Indication of support for recovery states

Jeff Slavick – Broadcom
Luz Osorio – Nokia
Comments I-248, I-249

General update

Figure 178B-10b—Training control state diagram, part 2

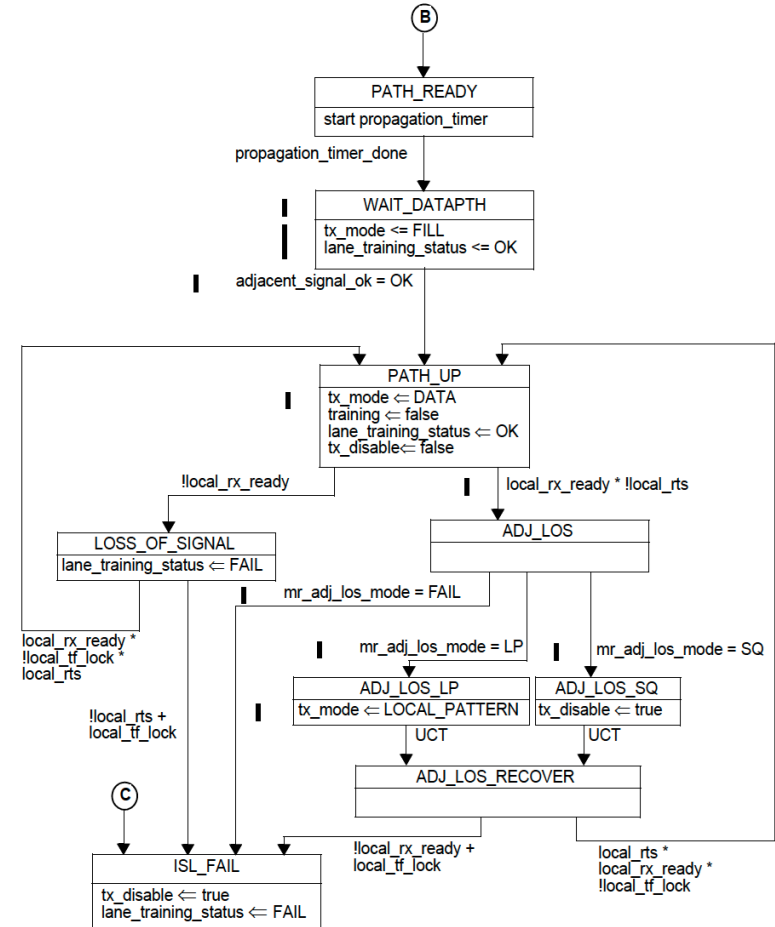
D3.1 Figure 178B-10b

With the updates to add recovery states we currently mandate all implementations must support all recovery methods.

Some implementations may not be capable of doing all these approaches.

The transition to FAIL state must be supported for all implementations. Requiring a restart aligns with the recovery mechanism prior to adding the new states (LOSS_OF_SIGNAL, ADJ_LOS*).

Figure 178B-10b—Training control state diagram, part 2

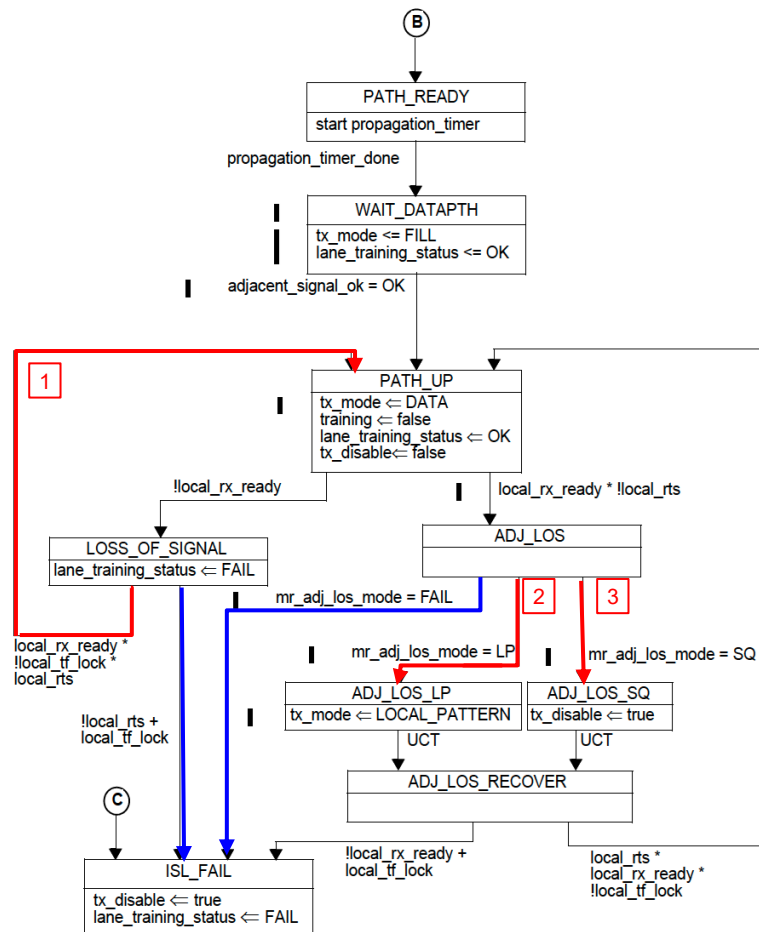
The two arcs marked in blue (to ISL_FAIL) need to be supported by all implementations.

The three paths marked in red (1,2,3) may not be supportable by all implementations.

For example, a receiver could be reliant on the training frames to achieve data lock.

For each of the paths 1, 2 and 3, specify an implementation dependent variable that indicates if a path is supported.

- Specify the ability variables in terms of the behavior that occurs when a path is followed. Describing the behavior is more useful to the reader than just listing if transitions between specific states are supported.
- In the transmit direction, management can configure the desired behavior, but based upon the interfaces abilities, it may go to the ISL_FAIL state instead of operating in the mode that management configured.

Note that the ability and configuration variables can be set uniquely per interface. For example, in a module, the PMD may only support going to ISL_FAIL, while upper AUI component could support all modes of operation.

Figure 178B-10b—Training control state diagram, part 2

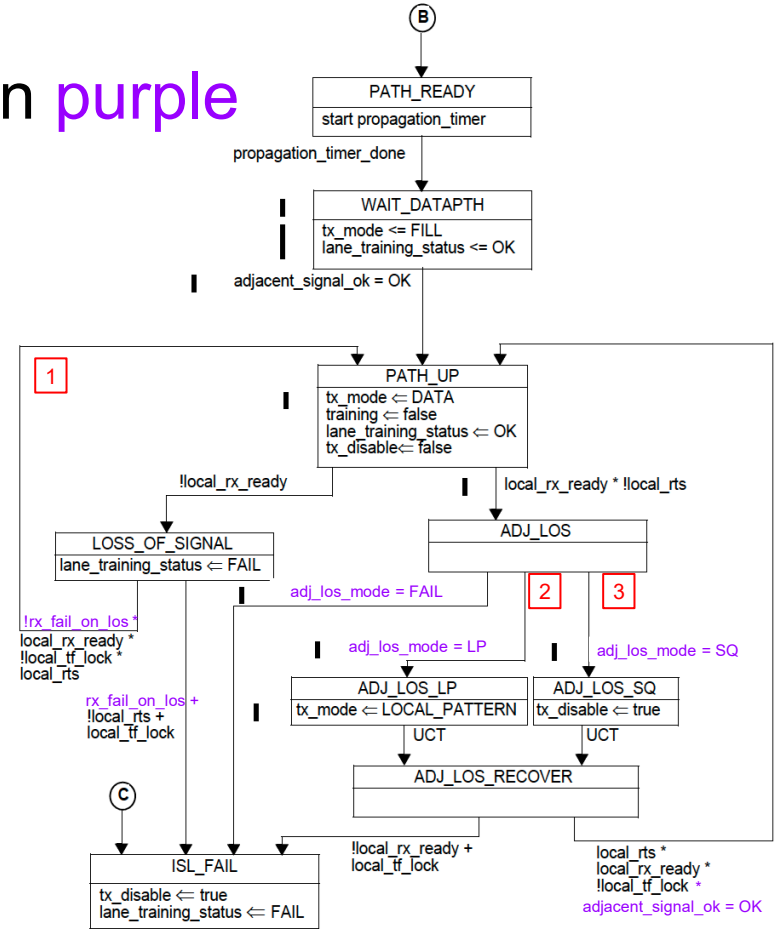
Figure 178B-10b updates shown in purple

Path 1 is not available when Rx recovery is not supported, as indicated by rx_fail_on_los

Paths 2 & 3 are not available when the mr_los_adj_mode that is set is not supported, as indicated with the ability variables. Logically as follows:

The path from ADJ_LOS_RECOVER to PATH_UP needs to be the same overall set of requirements as WAIT_DATAPATH to PATH_UP. So the requirement of adjacent_signal_ok being OK is added.

```
if (tx_lp_on_adj_los_ability) && (adj_los_mode == LP)
    adj_los_mode = LP
else if (tx_sq_on_adj_los_ability) && (adj_los_mode == SQ)
    adj_los_mode = SQ
else
    adj_los_mode = FAIL
```
